**Addendum to the Costco Wholesale Project  
Environmental Impact Report  
SCH # 2011112025**

**City of Ukiah**  
300 Seminary Ave  
Ukiah, CA 95482

**DUDEK**  
980 9<sup>th</sup> Street, Suite 1750  
Sacramento, CA 95814  
*Contact: Brian Grattidge*

NOVEMBER 2014

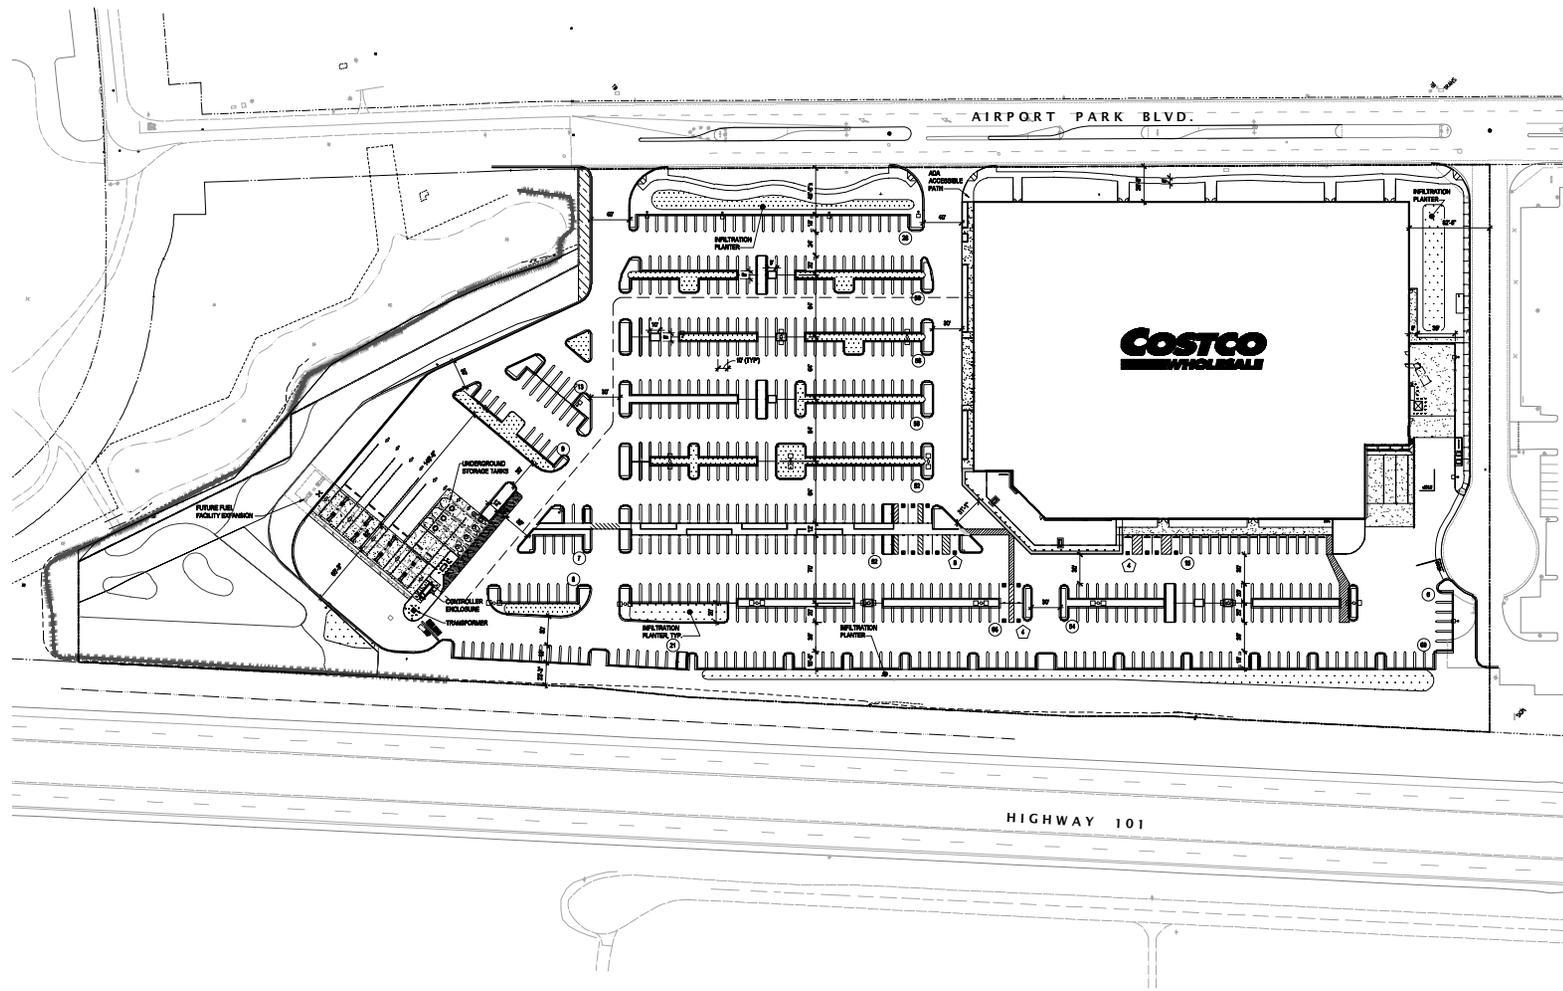
Final EIR Figure 2-3, Site Plan, has been replaced with the Revised Site Plan attached to this Addendum which reflects implementation of Mitigation Measure 3.6.4, as addressed below. The changes to the Site Plan, which are further described in Section 3.3, below, include identification of a buffer between the Project Site and the off-site wetlands, a detention basin, a change in the orientation of the fueling facility, a slight reduction in the size of the warehouse, a reduction in the size of the parking lot, additional bioswale areas, additional shade trees, and modification of the parking lot lighting.

A Final Drainage Plan has been submitted to the City and Regional Board as required. In order to accomplish the performance criteria of the Mitigation Measure, minor revisions to the Project Site Plan are required. Some of the key considerations in the development of the plan, and the resulting changes to the Site Plan (see Revised Site Plan), are described below:

1. Measure 3.6.4 requires inclusion of water quality features. The proposed site storm water treatment is modified to meet the following specific project concerns from the Regional Board:
  - a. Maximizes the use of low impact development practices throughout the site, including additional bioswales.
  - b. Consolidates two (2) existing wetland drainage outfalls into one (1) that discharges to a constructed wetland area that provides the following characteristics:
    - i. Separation from new storm drain outfall and existing wetland area
    - ii. Enhance habitat for wildlife
    - iii. Additional floodplain storage

2. Enhances habitat between the parking lot/fueling facility and the wetland. This is accomplished by rotating the fuel facility (see Revised Site Plan).

3. Reduces the amount of parking to accommodate the enhanced habitat and additional bioswales (see Revised Site Plan).
4. Rehabilitates the wetland area and the enhanced habitat and addresses on-site landscaping improvements by:

- a. Revising tree species near wetland area to California natives (Valley Oaks and Interior Live Oaks).
  - b. Incorporating wetland grasses adjacent to and within the expanded planting areas south of the gas station (4 different species).

- c. Modifying tree layout to conform to new bio-swales within the parking lot and behind the building.
  - d. Adding additional shade trees in parking area to comply with parking lot shading requirement.

- e. Revising shrub planning to incorporate more California native species.
5. Decreases the size of the warehouse, from 148,000 SF to 141,000 SF.
6. Relocates and redesigns parking lot lighting to shield enhanced habitat area from potential lighting spillover (note that this change is also consistent with Mitigation Measure 3.1.2 regarding lighting spillover).

7. Increases water flow into wetland to insure wetland sustainability.

The rotation of the fueling facility does not adversely affect vehicular circulation on-site or pedestrian safety (see Revised Site Plan). However, it does accommodate the enhanced habitat between the Project and the adjacent wetland, while providing for a storm drainage system that meets the requirements of Mitigation Measure 3.64 and all storm water quality and volume standards.

The EIR assumes a maximum warehouse size of 148,000 SF. In order to better accommodate the enhanced habitat area, the drainage plan and the associated changes to the Site Plan, the warehouse size has been reduced by approximately 5%, to 141,125 SF. As the impact analysis in the EIR assumes the larger building size, all Project impacts for the 141,125 SF warehouse would be either the same or slightly less than those identified in the certified Final EIR. The reduced parking still meets City parking standards for the smaller warehouse, and in fact addresses public concerns raised during the Project hearings that the Project was over-parked. The Site Plan approved on January 22, 2014, provided for 607 parking spaces. This amount of parking exceeded the 592 spaces required by the City's development code, based on a 148,000 SF warehouse. The Revised Site Plan (Figure 2-3) includes a 141,125 SF warehouse and 579 spaces. The 579 proposed parking spaces meet the minimum parking requirement of 565, based on a 141,125 SF building.
